Proposed Marlborough Environment Plan

Section 42A Hearings Report for Hearing Commencing 28th May 2018

Addendum to Report dated 23 April 2018
Report on submissions and further submissions on Topic
9: Natural Hazards

Report prepared by
Gavin Cooper (Consultant Planner)
Laddie Kuta (Consultant Rivers Engineer)

Figure 1: Extract from PMEP highlighting submitters land

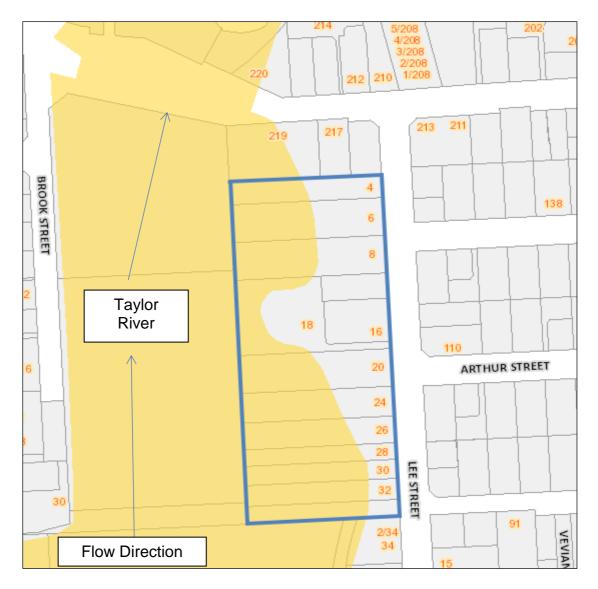
- 13. Specifically, the submission by Lee Street Residents **opposes** the Level 3 Flood Hazard Overlay layer over the residential properties at 4, 18, 20, 24, 26, 28, 30 & 32 Lee Street.

- 14. To assist with the evaluation, we attach extract from PMEP at Figure 1 which shows the general area of the submitters affected land at Lee Street (blue border)¹. The affected land is zoned Urban Residential 1 in the PMEP. The yellow highlight shows the extent of the Level 3 Flood Hazard Overlay in the PMEP and follows the existing stopbank alignment to the landward toe side.

- 18. The submitter considers that Level 3 Flood Hazard Overlay is overstated on the residential properties listed.
- 19. The submitter seeks:
- To have the Level 3 Flood Hazard Overlay layer reviewed and reduced to Level 1
- A more appropriate and better boundary between floodway, recreation and residential properties by relocating the floodway stopbank to outside the residential properties. This would then allow the Designated Land boundary to be outside the residential properties.

Reject Submission.

Retain existing Level 3 Flood Hazard Overlay extent identified at Map 23, Vol 4.

Figure 2: Taylor River stopbank reconstruction sections

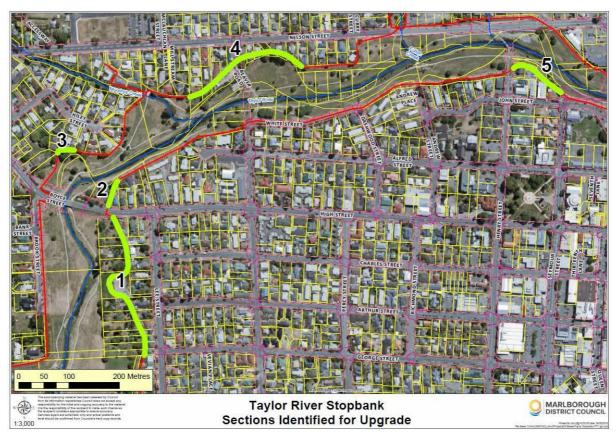
- 22. Council has an approved programme of stopbank improvements on the Taylor River (refer Figure 2 overleaf for locations).
- 23. Houses on this side of Lee Street are situated on the old river terrace with the existing stopbank generally located on the river terrace edge.

- 24. The Lee Street area is one of the five stopbank reconstruction areas on the Taylor River that Council has highlighted needs review and upgrading (refer 1).

- 25. Council has completed upgrade works at sections 2 & 3 and intends on undertaking works at area 4 next (refer Figure 2).

- 27. At Lee Street the designated stopbank is currently well back from the river boundary (refer 1 at Figure 2) so the level of control Council needs does significantly limit how a large portion of the private land can be used. This is a historical situation.
